PAINT MINE ID TEAM

Subject: Sunshine Quartz/Hematite Claims Project – Exploration and Development,
Data/Information Needs for the Environmental Analysis and Evaluation Process

We are underway with the environmental analysis and evaluation of the subject project. Additional data and information are needed to meet the requirements of the National Environmental Policy Act (NEPA) and associated Forest Service direction, in regards to: public scoping, purpose and need, reasonable range of alternatives, reasonable foreseeable actions, connected actions, and cumulative affects. We also need clarification of existing data and information provided to us in recent months.

Illustration of Typical Gabion Rock Wall Section

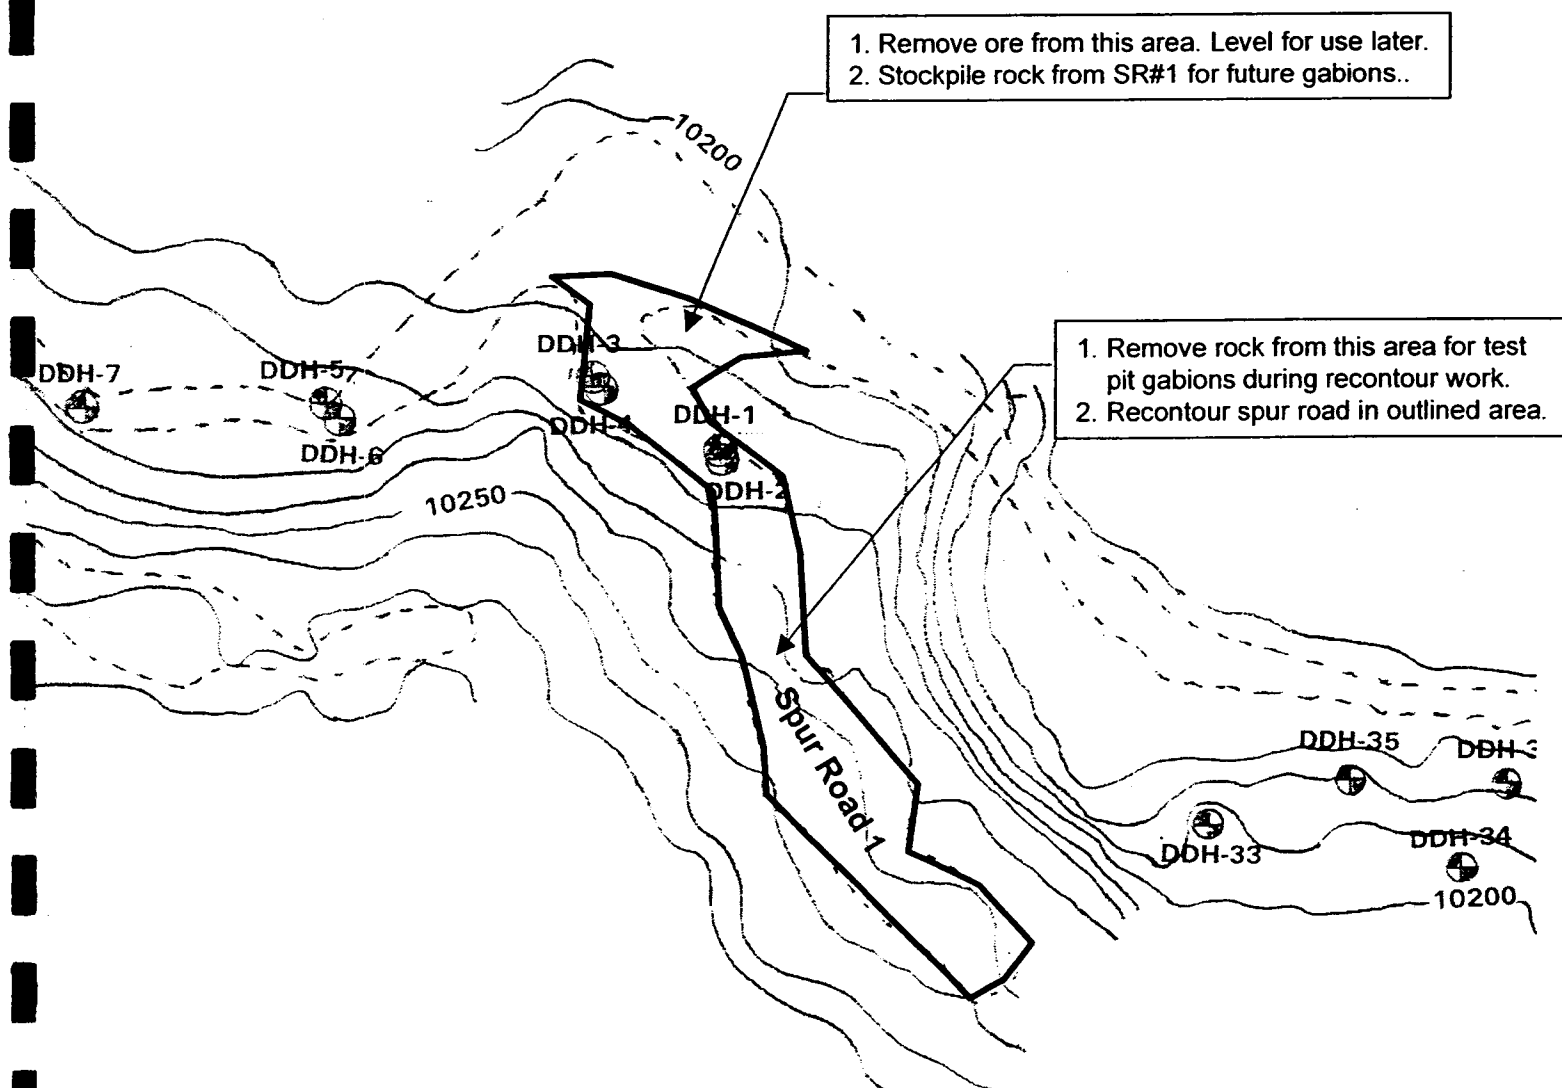
The "gabion rock wall" will be addressed as one of the protective measures being proposed by Uintah Mountain Cooper Company. Please provide us with an illustration of the latest gabion design (as modified in response to comments from our geotechnical engineer). The illustration can be sized to 8 x 11 or 11 x 14.

Wall height, H , varies from 8 to 10.5 ft
 Gabion baskets stagger, s , 12 ± 3 inches
 Wall inclination at time of construction, $\delta = 10^\circ$ to 15°
